IN THE MATTER OF Stage 3 Proposed District Plan – General Industrial
Zone

BETWEEN Cardrona Cattle Company Limited (Submitter
#3349)

SITE Victoria Flats Road

**TRANSPORTATION EVIDENCE OF RAYMOND JOHN EDWARDS IN SUPPORT OF
THE SUBMISSION OF CARDRONA CATTLE COMPANY LIMITED (Submitter #3349)**

Gibbston Highway- Proposed Roundabout and updated road layout

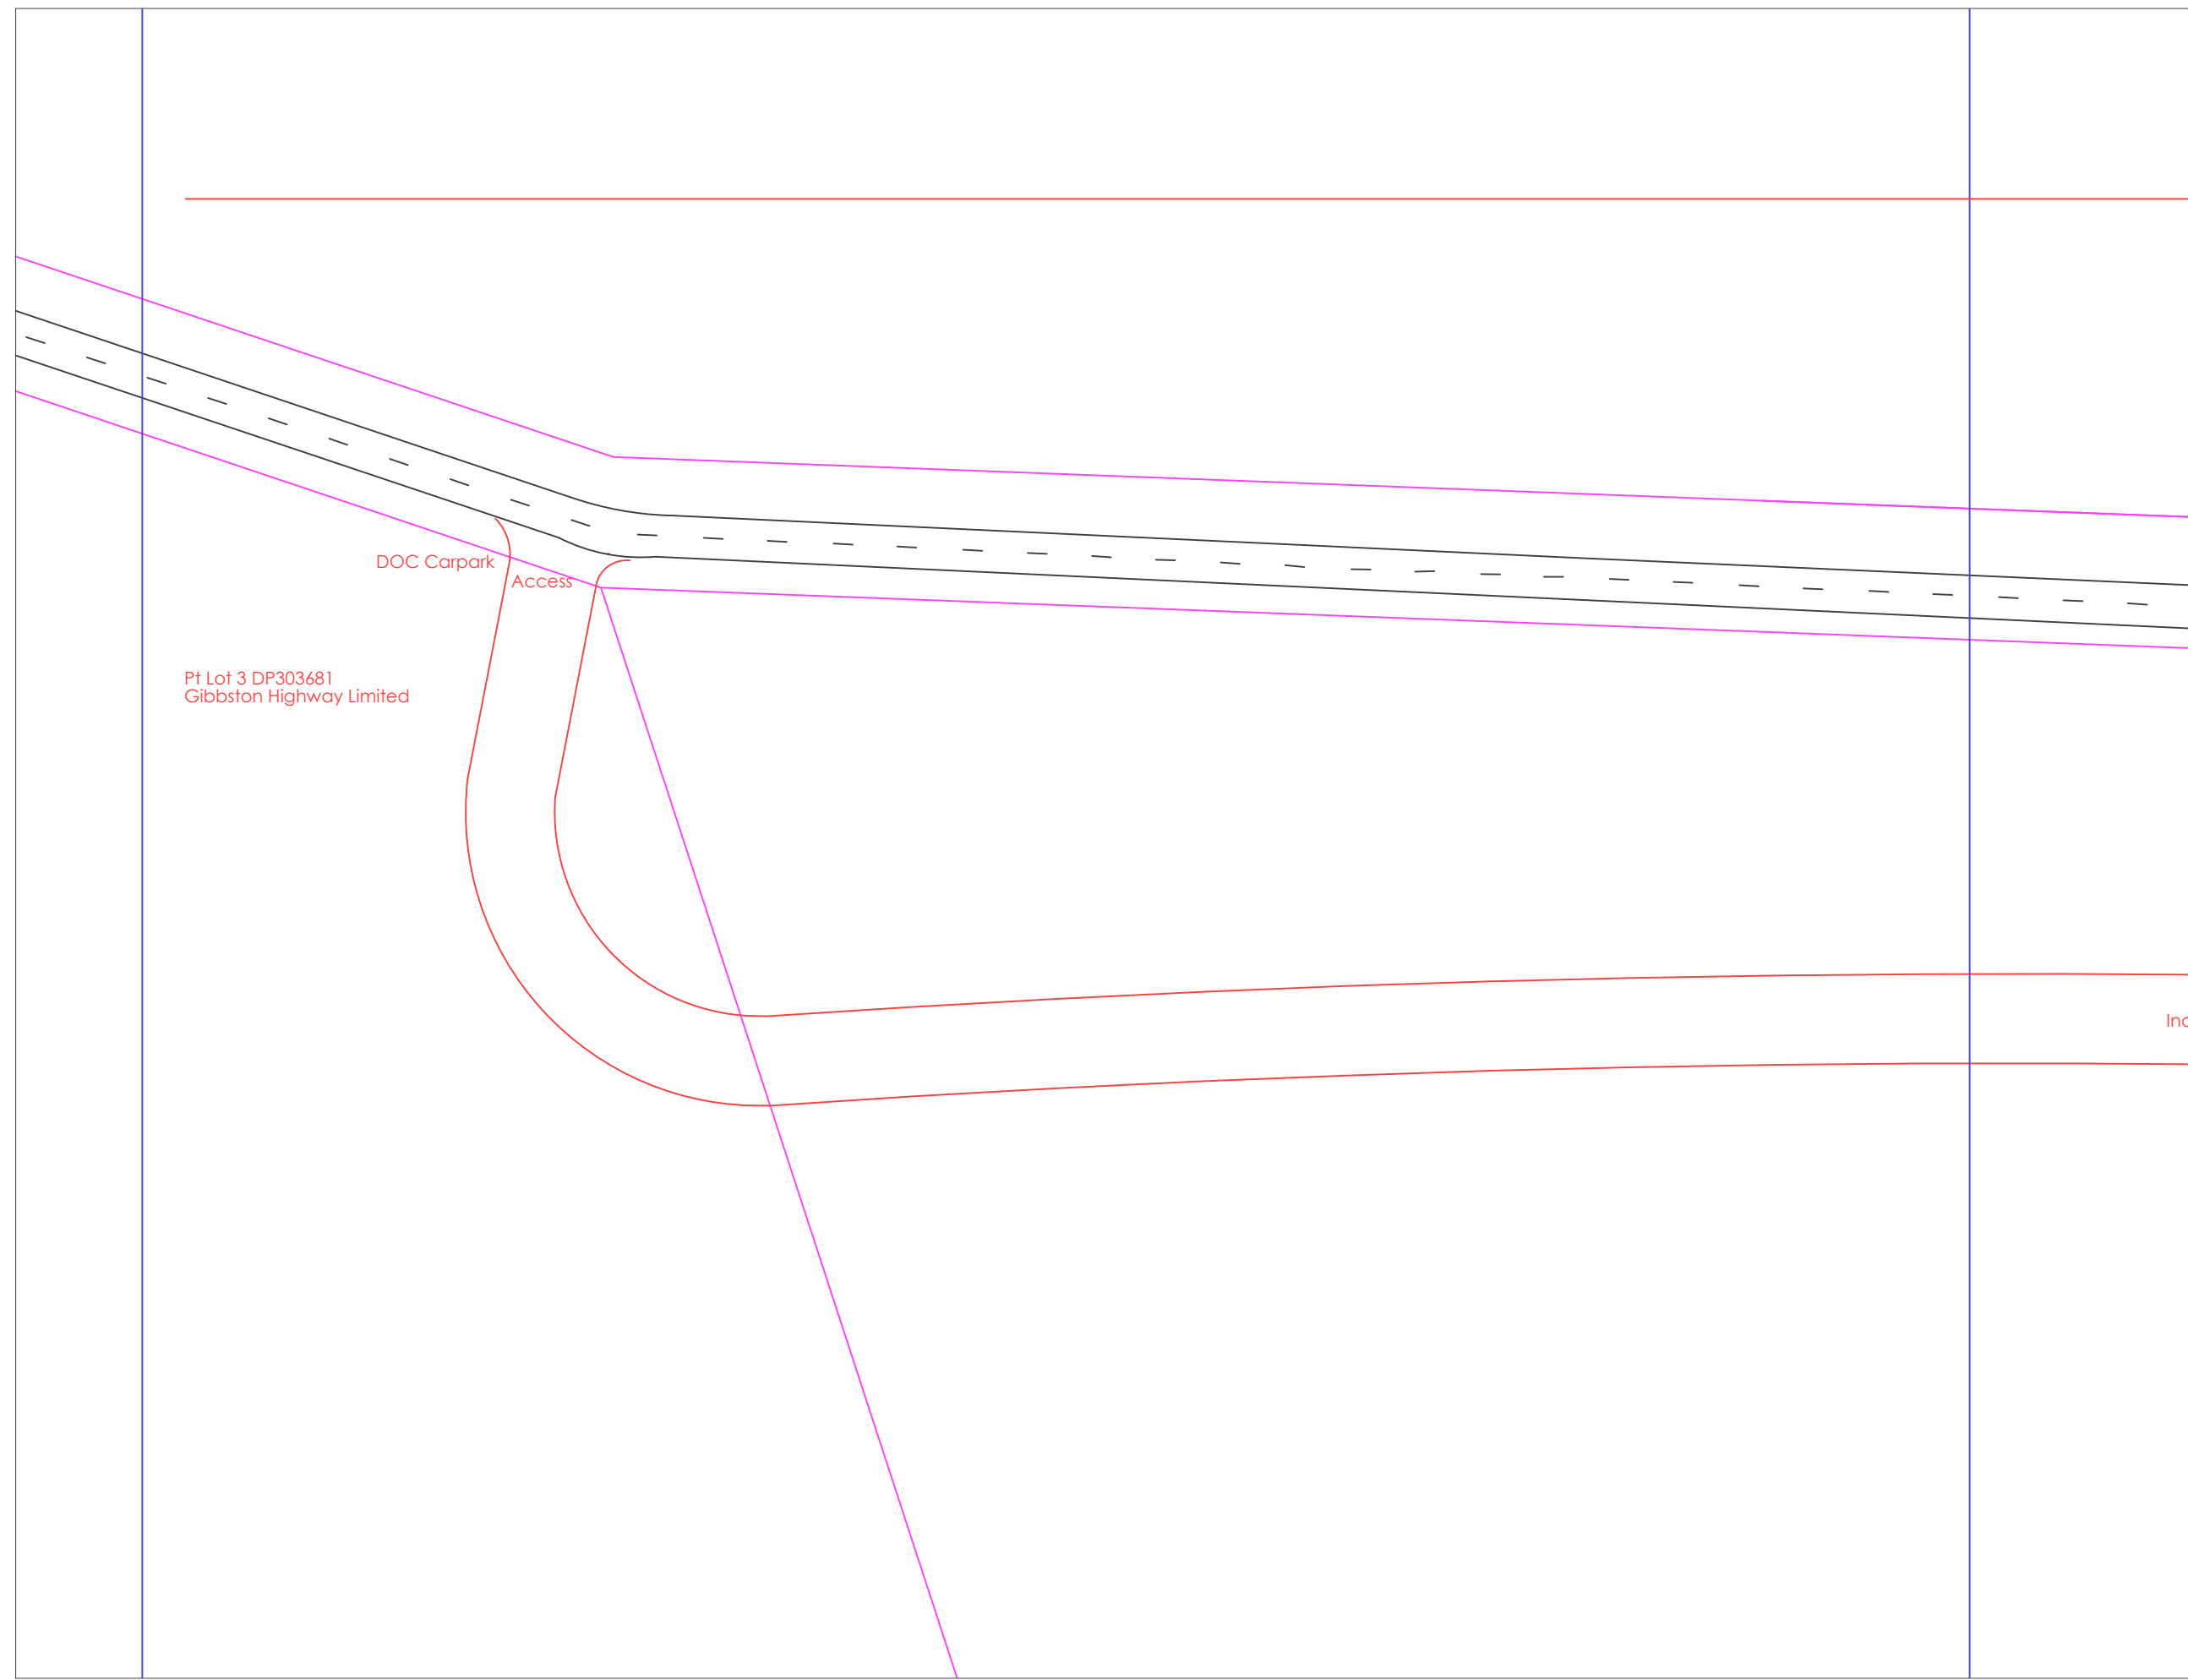
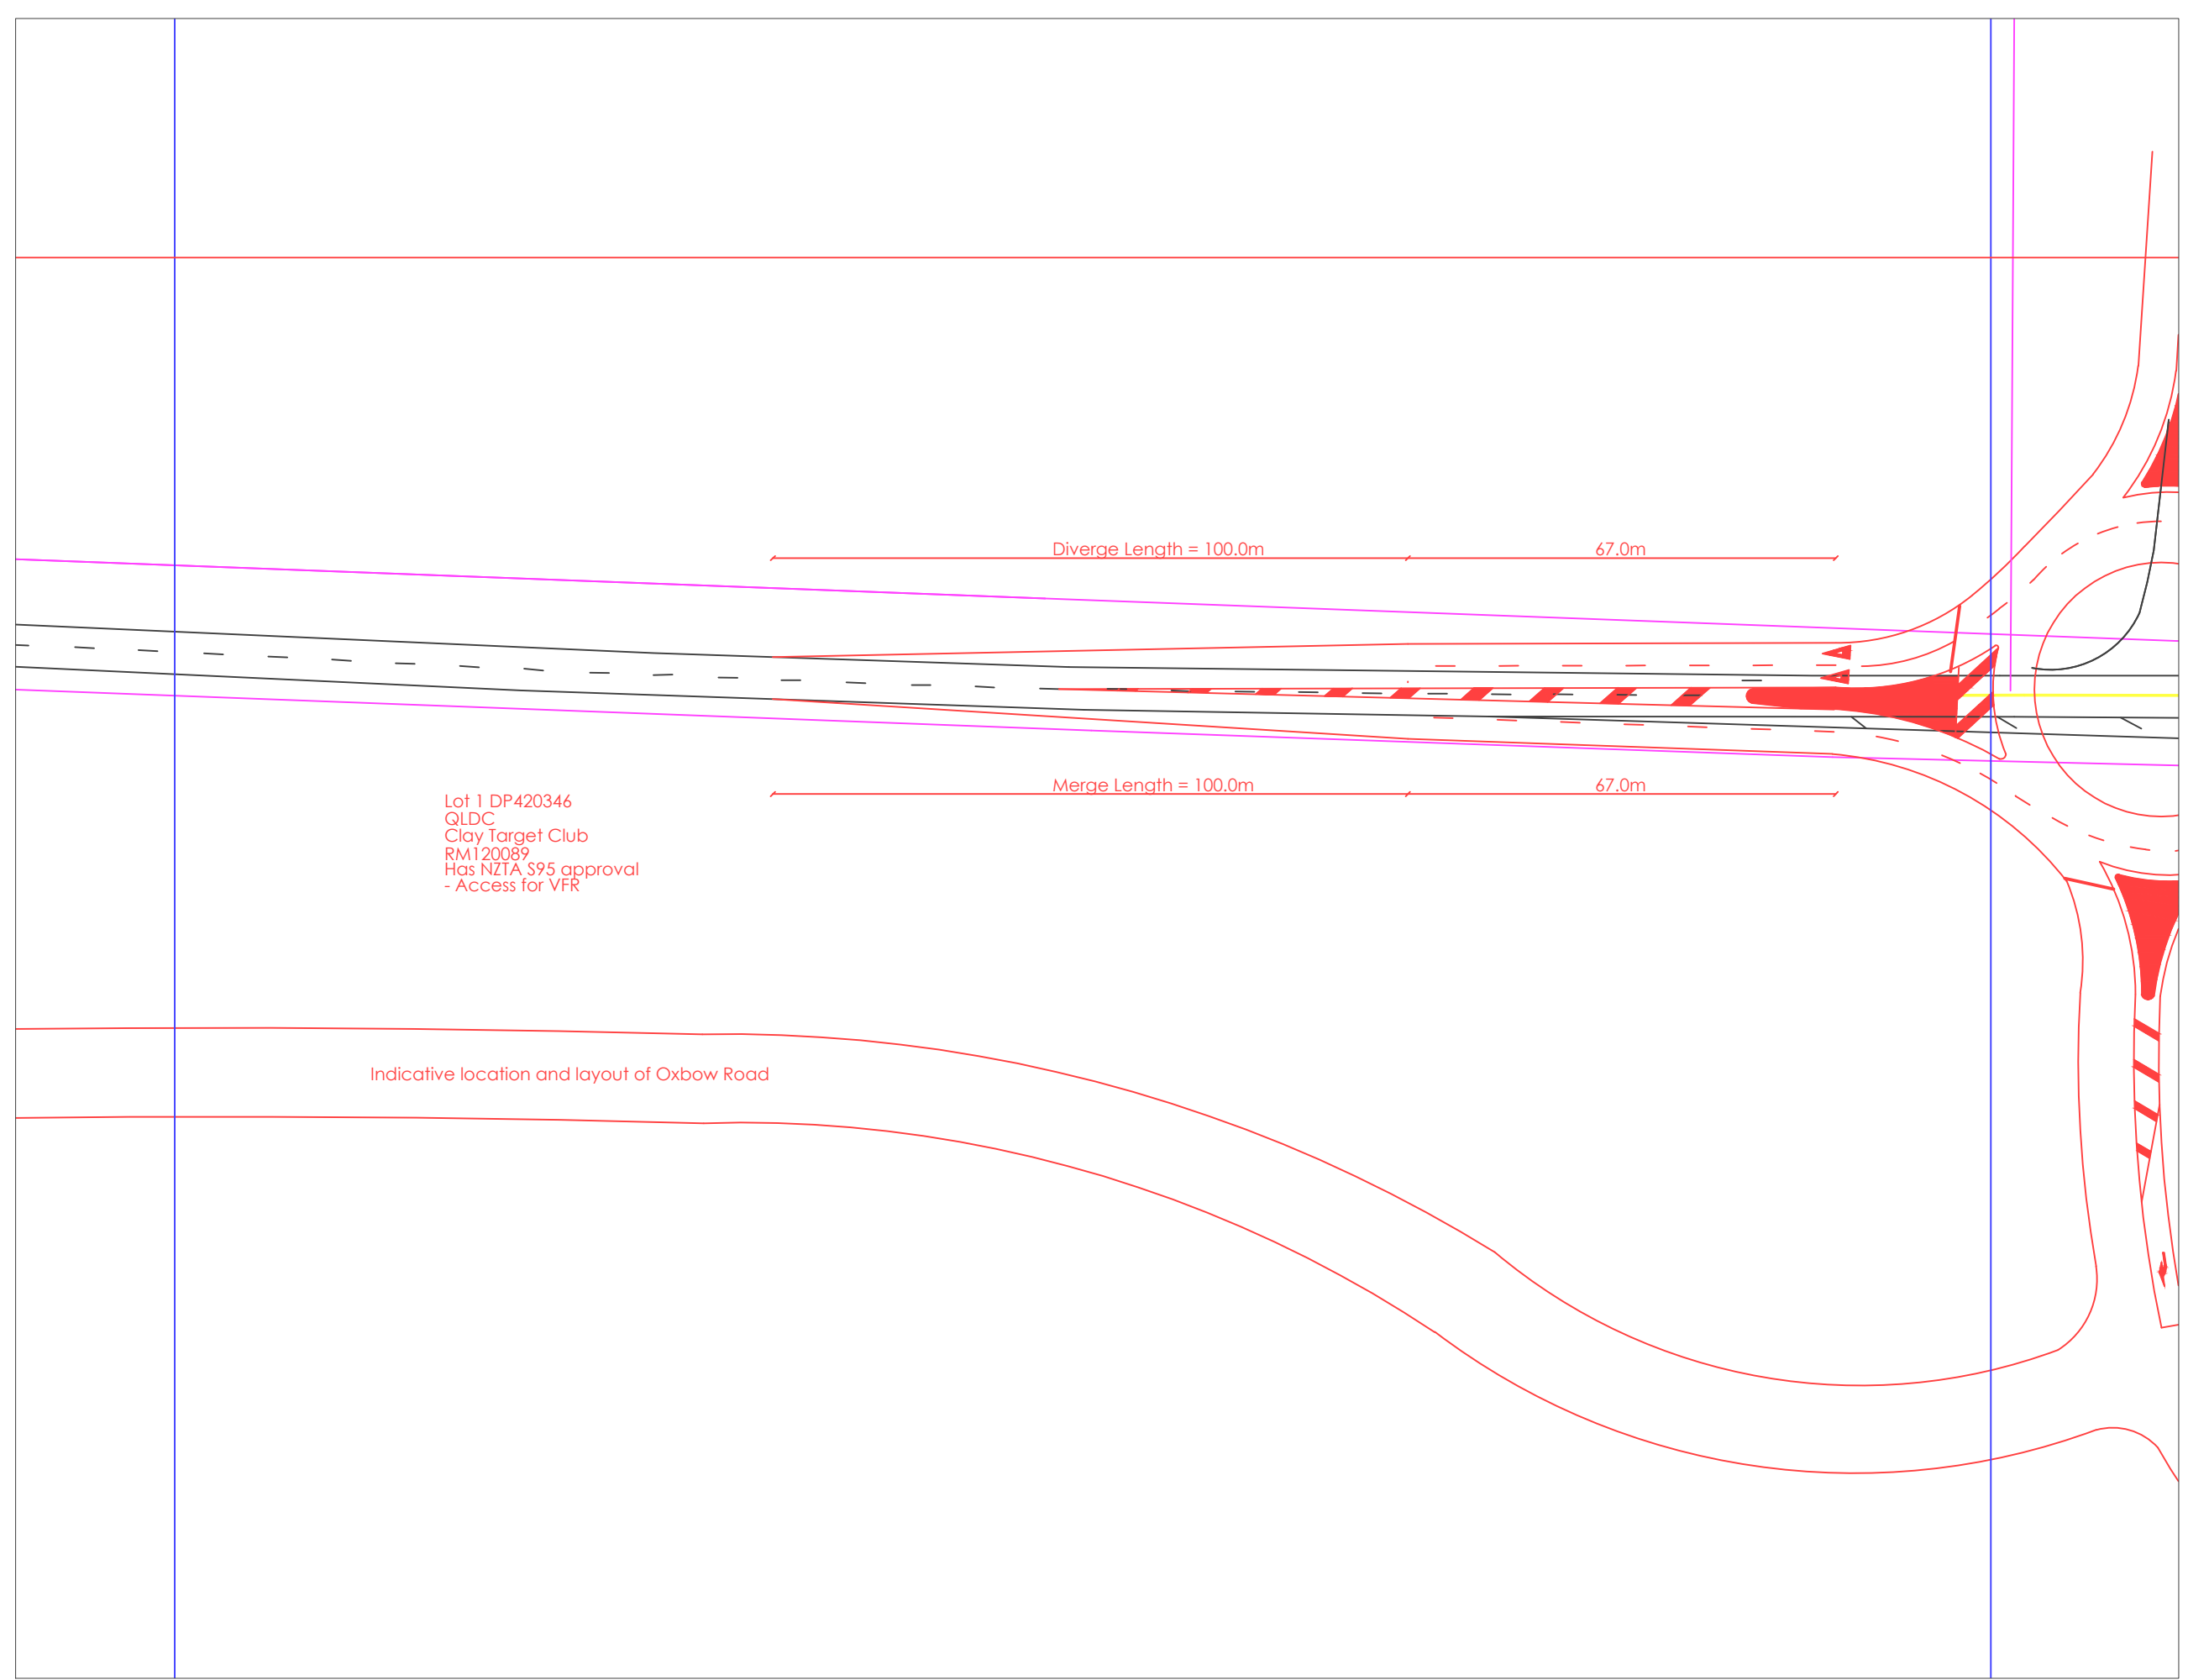
Thank you for providing the information on your client's wider proposal for Victoria Flats. The information provided included the traffic assessment conclusions for the wider development for Victoria Flats (Stage 2) and plans for an interim priority control intersection at Victoria Flats Road and SH6 as well as the potential for a roundabout should significant development occurs in the future. Information and links were also provided for the applicant's submission to the Queenstown Lakes District Proposed District Plan (Proposed Plan) for this area.

- The potential scale and intensity of the proposed landuse. We note the Council Officers report for the Proposed Plan recommendation is to reject your client's and Waitiri Ltd submissions to rezone the land in this area to Gibbston Industrial. As a result, we consider the outcome of the Proposed Plan process is likely to affect the scale of the Masterplan.

- The Agency also has concerns around the scale of industrial and residential landuse presented in the Masterplan and the appropriateness of the location for these activities. Also, following on from this – concerns around what the nature of the landuses that may be attracted to this location if the Masterplan went ahead, and;

- The information provided to date does not include an assessment of how the activities represented by the Masterplan will affect the overall capacity of highway network and in particular the capacity of the Shotover Bridge.

Therefore, assessing plans for road improvements with a view to providing the Agency written approval to the Masterplan is considered premature at this point. However, we do note if the proposal goes forward and a resource consent application is prepared (or a application for a private plan change) that, subject to an assessment of effects of the proposal on the highway network capacity, an engineered solution for road improvements to mitigate the effects on the highway could be identified.

Once your client is at the point where the Masterplan can be refined further, and a resource consent application is being prepared we would be happy to revisit this proposal.
